INTERNAL MEMORANDUM

FROM: HIGHWAYS & TRANSPORT; PLACE DIRECTORATE

Application: 22/P/0459/OUT

Proposal: Outline planning application for the erection of up to 90no. dwellings (including 30% affordable housing), public open space, children's play area, landscaping, sustainable urban drainage system and engineering works, with vehicular access off Mulberry Road. All matters reserved except for means of access.

Visibility

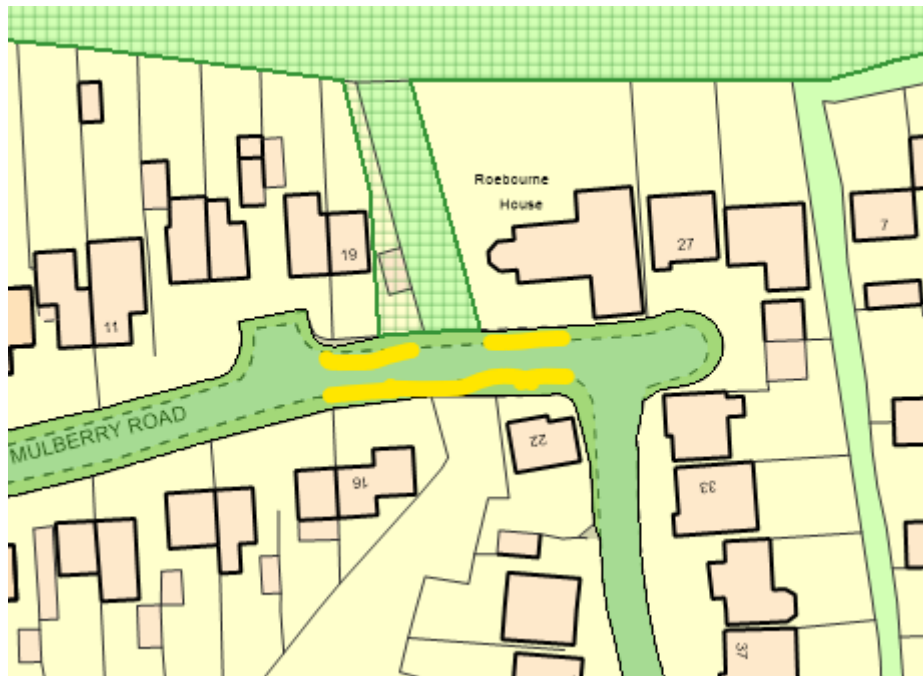
A proposed vehicular access showing the visibility splays is included in the transport assessment appendices. These visibility splays are not drawn correctly. The set-back needs to be dimensioned (at a point 2.4 meters back from the edge of the carriageway) and the end points should be drawn to the near edge of the carriageway with no obstructions. As Mulberry Road is subject to a 30mph speed limit, at a point 2.4 meters back from the edge of the carriageway, 43 meters of visibility should be achievable from the access as outlined in Manual for Streets.

The applicant should submit **revised plans** showing a correctly drawn visibility splay.

Active travel

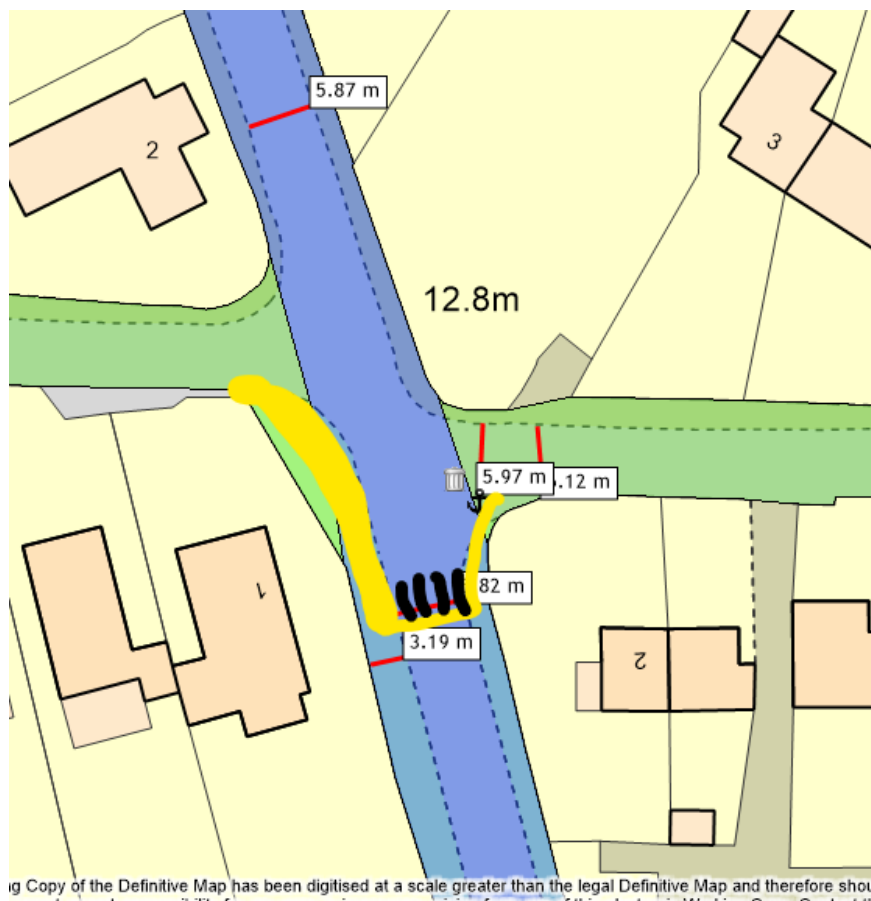
The development needs to be designed with active travel first and this must be provided for at reserved matters application stage, giving pedestrian priority at the site access and within site.

Tiger crossing at Brinsea Road and provision of short section of 3m shared foot/cycleway subject to the outcome of a Road Safety Audit and design in accordance with LTN1/20. Improvements to be delivered by Section 278 agreement (as within the adopted highway) and secured by **condition**.

The footway width as shown in the image below is substandard and we **require** the developer to make improvements at this junction to widen the footway to a minimum of 1.8 meters to match Brinsea Road. Improvements to be delivered by Section 278 agreement (as within the adopted highway) and secured by **condition**.
